*Chick-fil-A Powers and Palmer Park
El Paso County, Colorado*

Grading, Erosion and Stormwater Quality Control Report

CHICK-FIL-A, POWERS & PALMER PARK #05934

Add: PCD File No. PPR2521

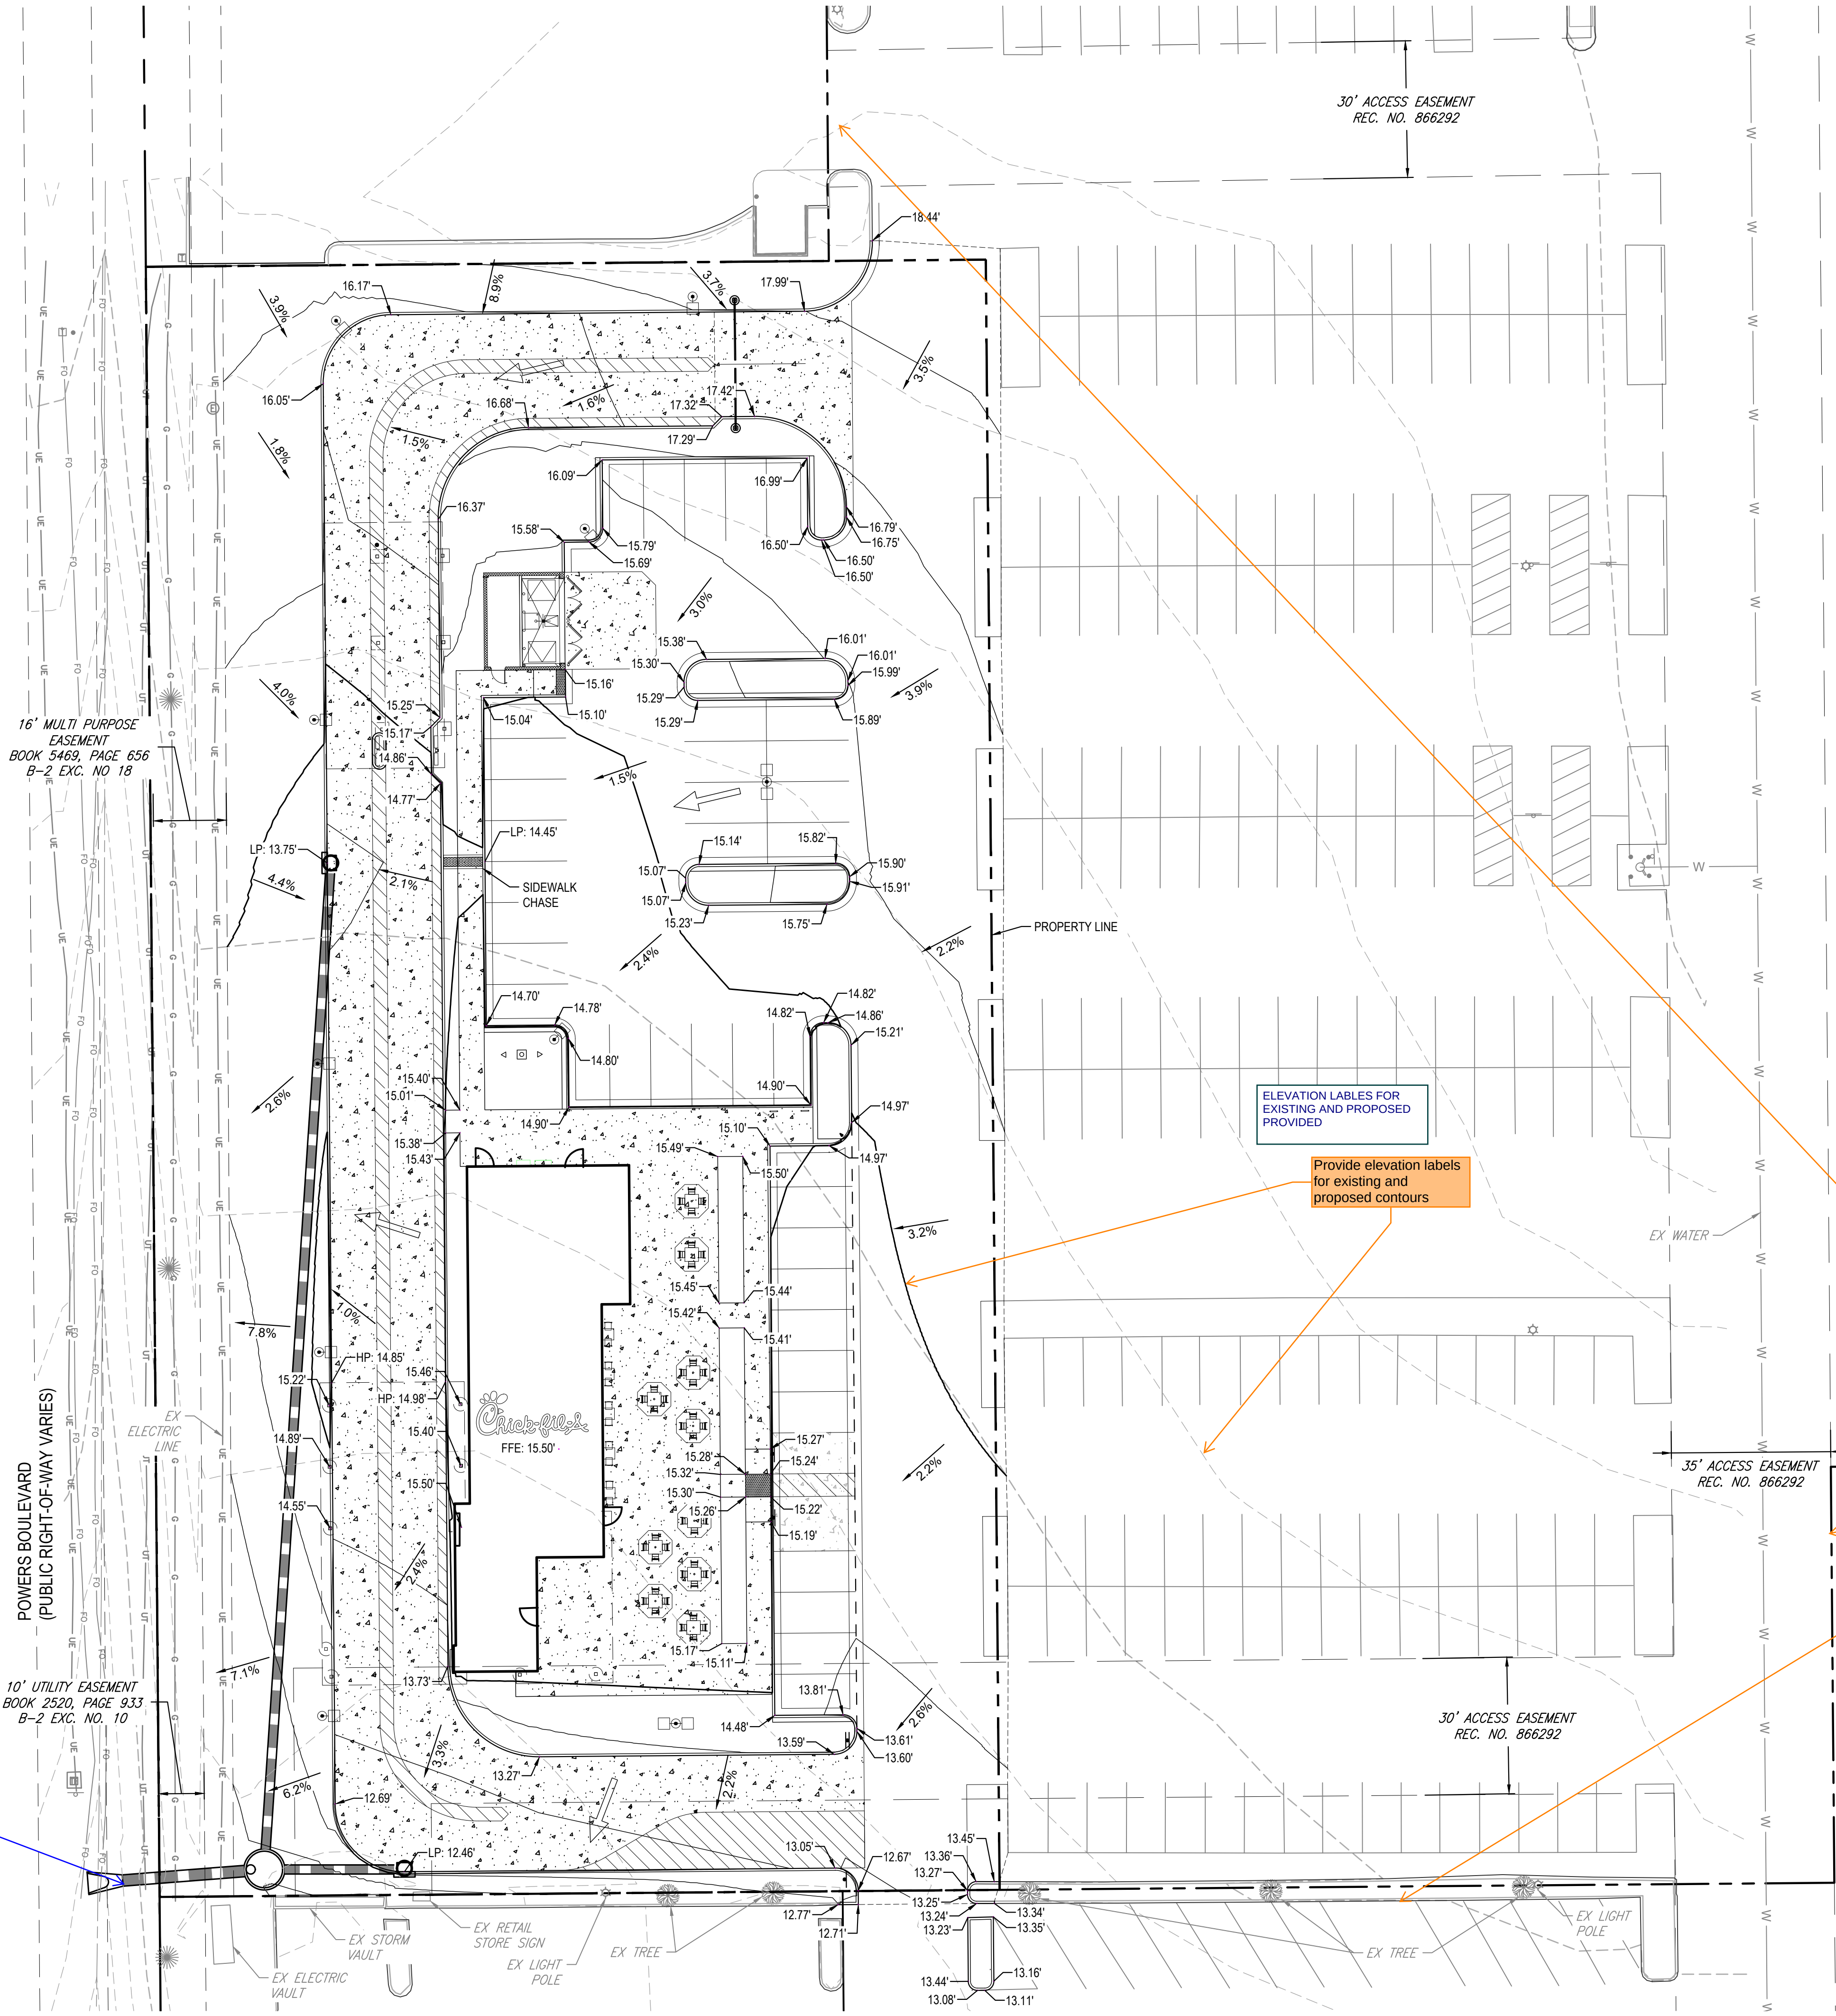
show all grading
Pipe needs to be set
back inside property
line with rip rap
protection

Checklist item O. Show proposed areas of cut and fill.

Checklist item C. Provide labels for adjacent city/town/jurisdictional boundaries, subdivision names, and property parcel numbers (Typical comment for all GEC sheets).

C3.0

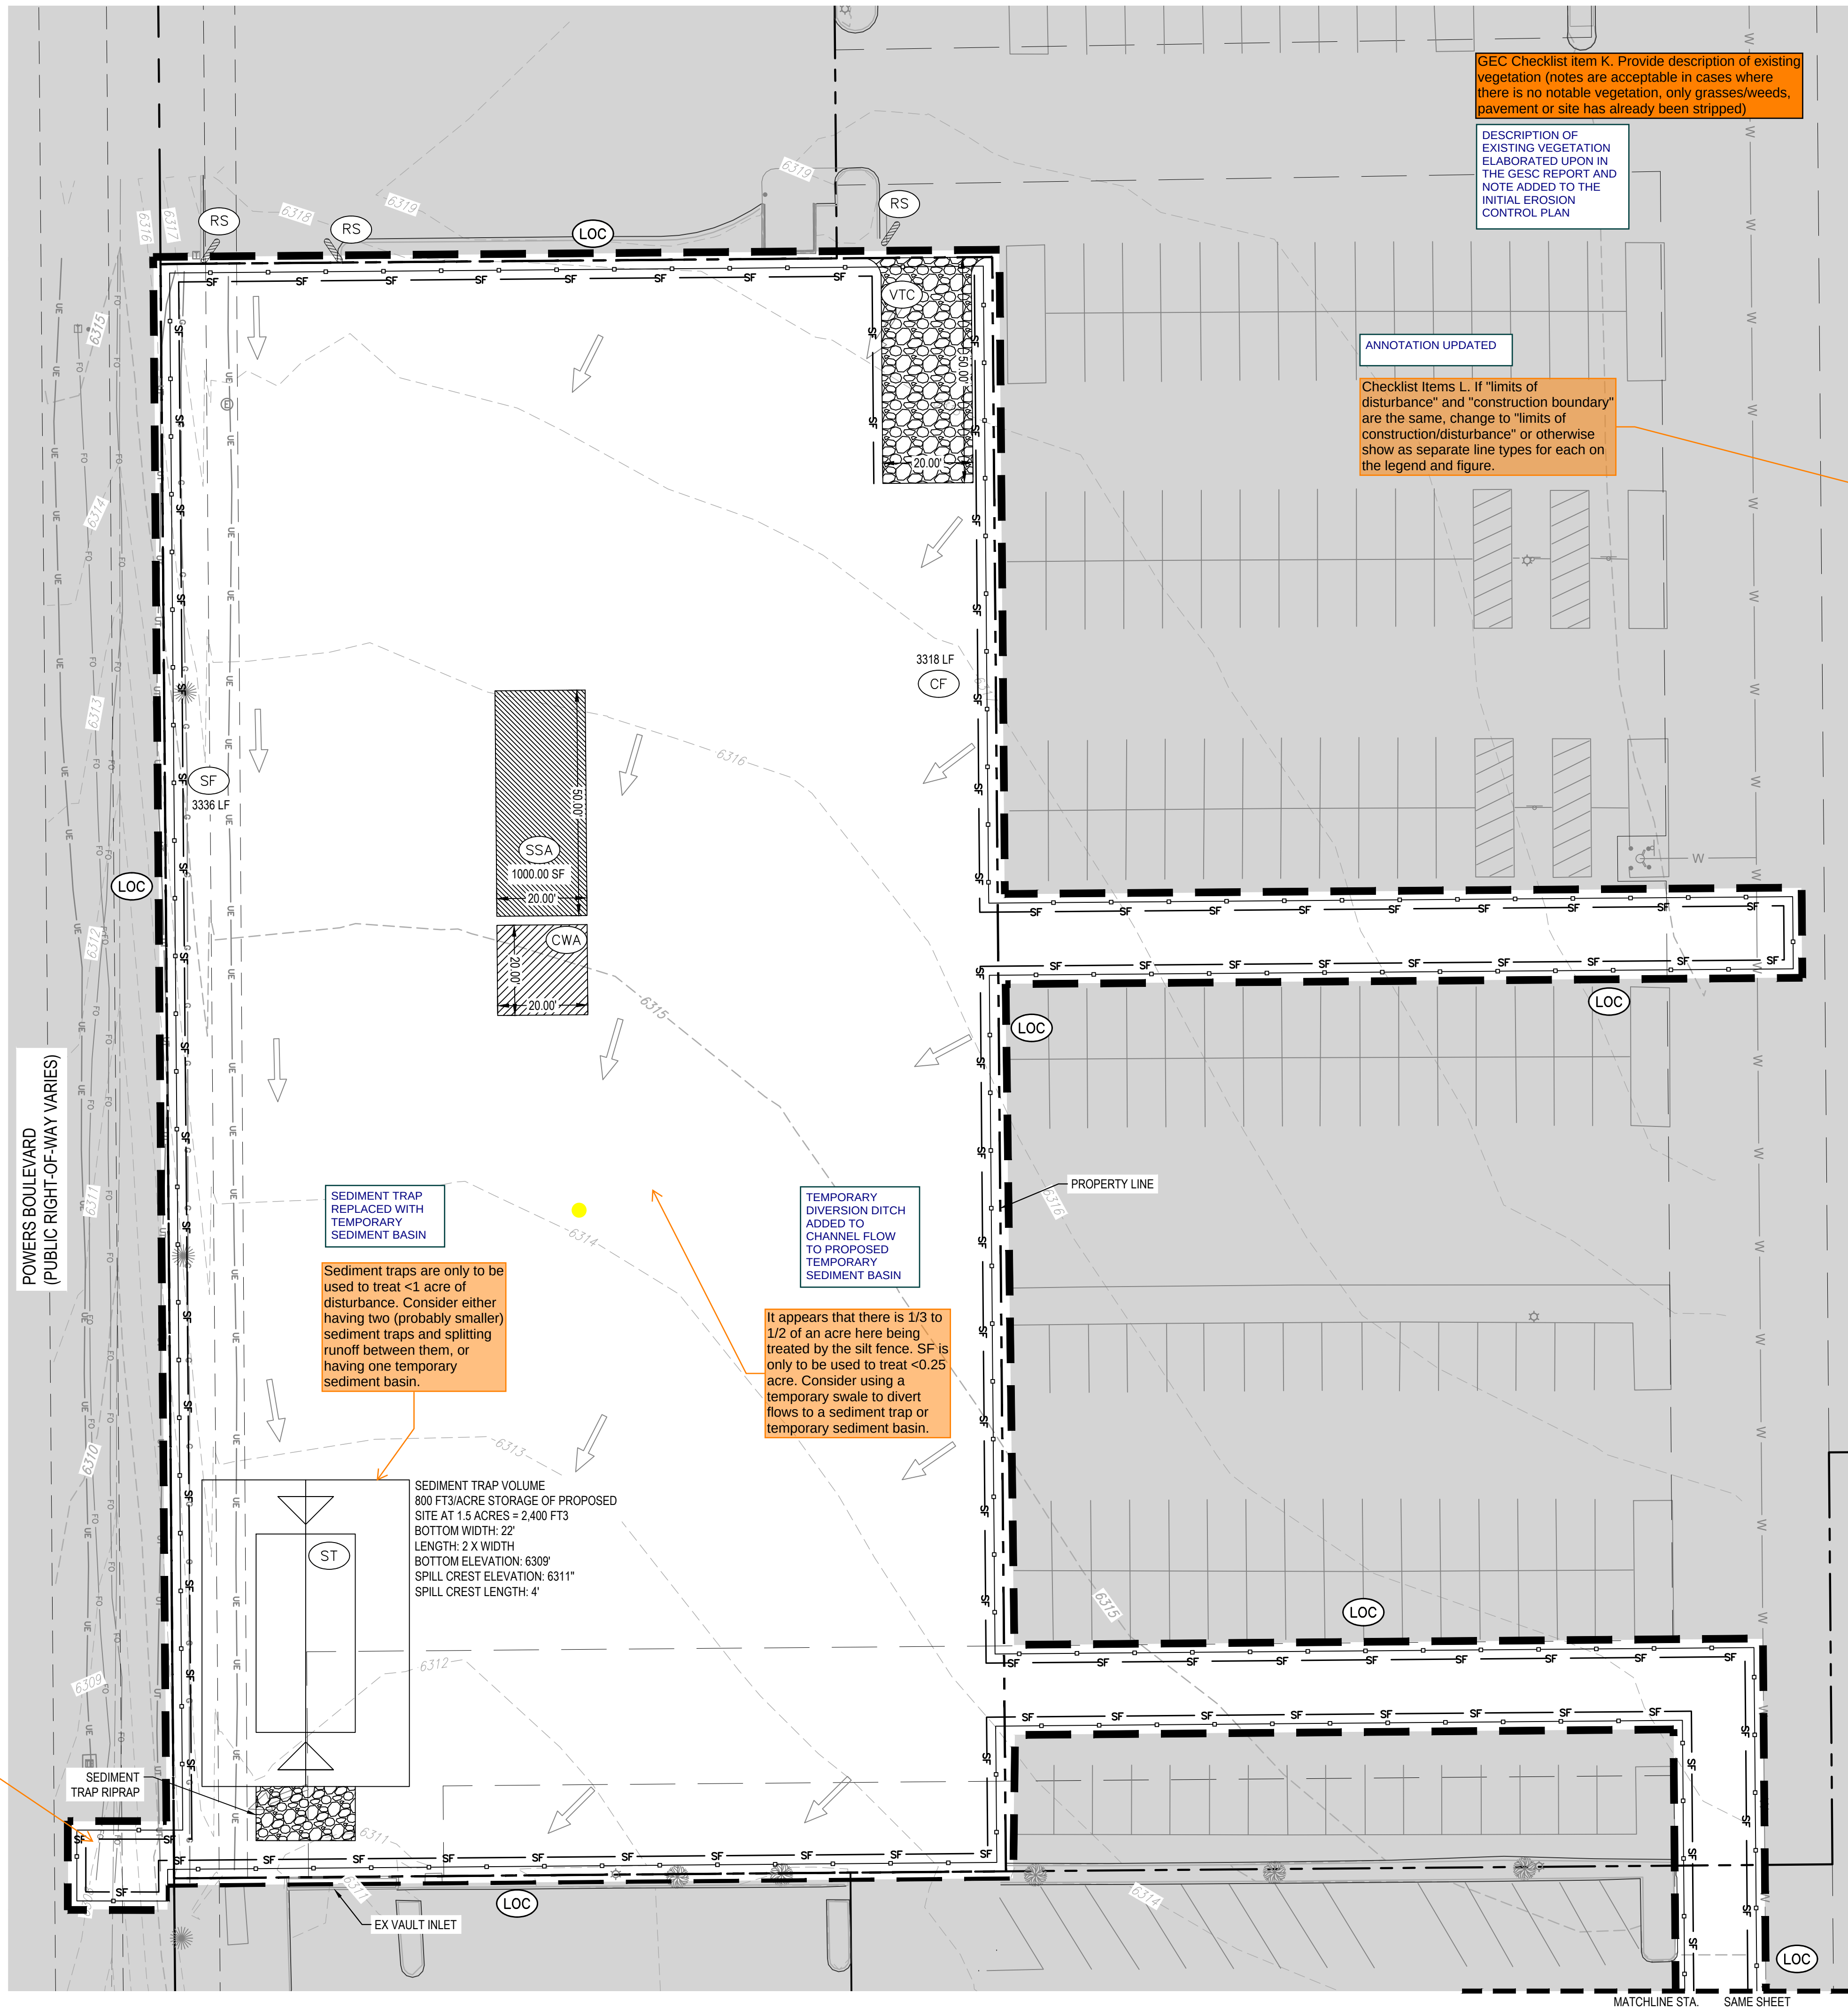
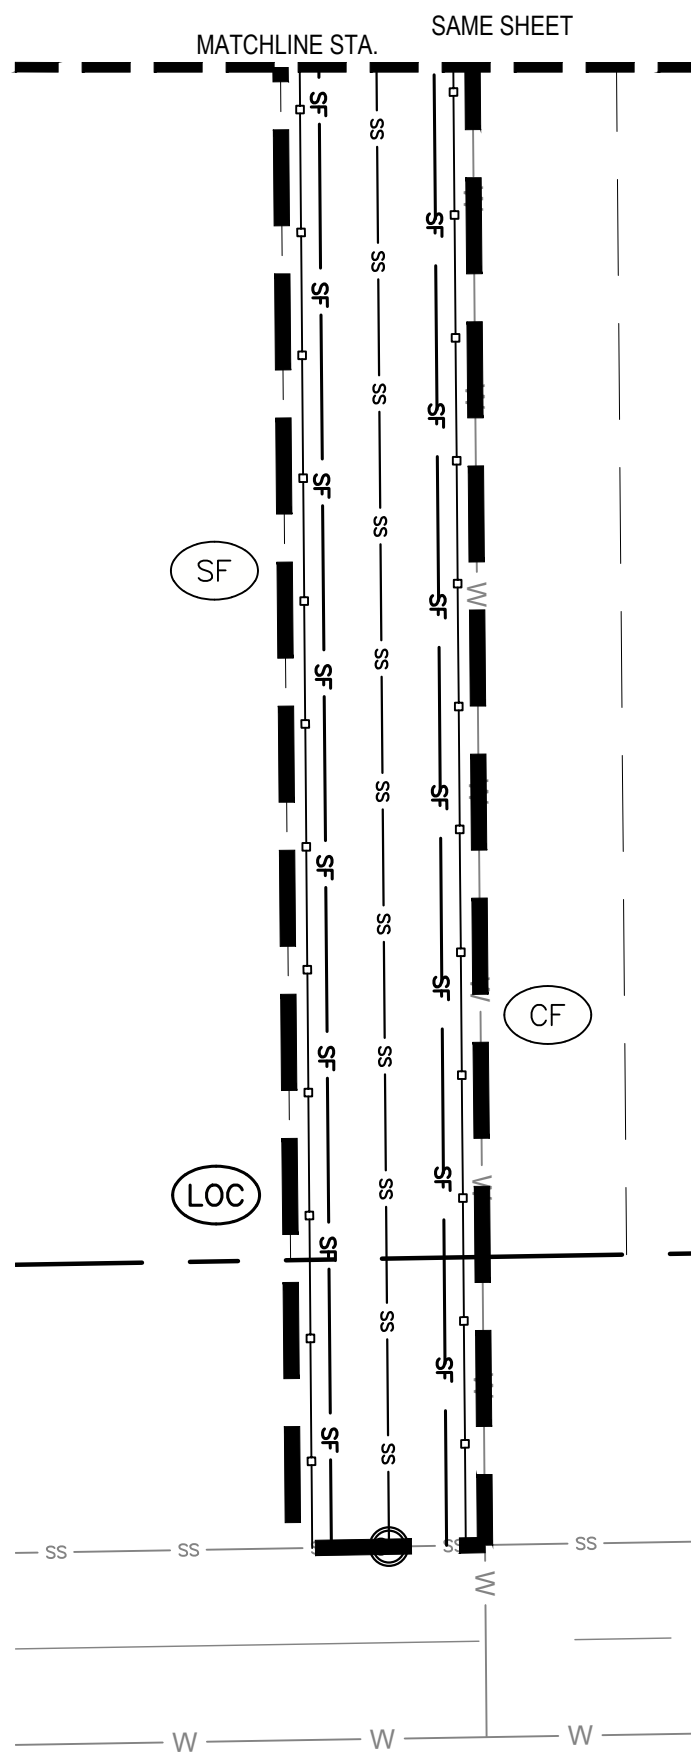
Checklist item E.
Disturbances outside of
property line require
written permission from
owner. Provide copy of
owner permission to EPC.

GESC Checklist item K. Provide description of existing vegetation (notes are acceptable in cases where there is no notable vegetation, only grasses/weeds, pavement or site has already been stripped)

Checklist Items L. If "limits of disturbance" and "construction boundary" are the same, change to "limits of construction/disturbance" or otherwise show as separate line types for each on the legend and figure.

PIPE NETWORK
REMOVED IN NEW
RAIN GARDEN
DESIGN. NO
DISTURBANCE
OUTSIDE OF
PROPERTY LINE

DESCRIPTION OF EXISTING VEGETATION ELABORATED UPON IN THE GESC REPORT AND NOTE ADDED TO THE INITIAL EROSION CONTROL PLAN

TEMPORARY DIVERSION DITCH
ADDED TO
CHANNEL FLOW
TO PROPOSED
TEMPORARY
SEDIMENT BASIN
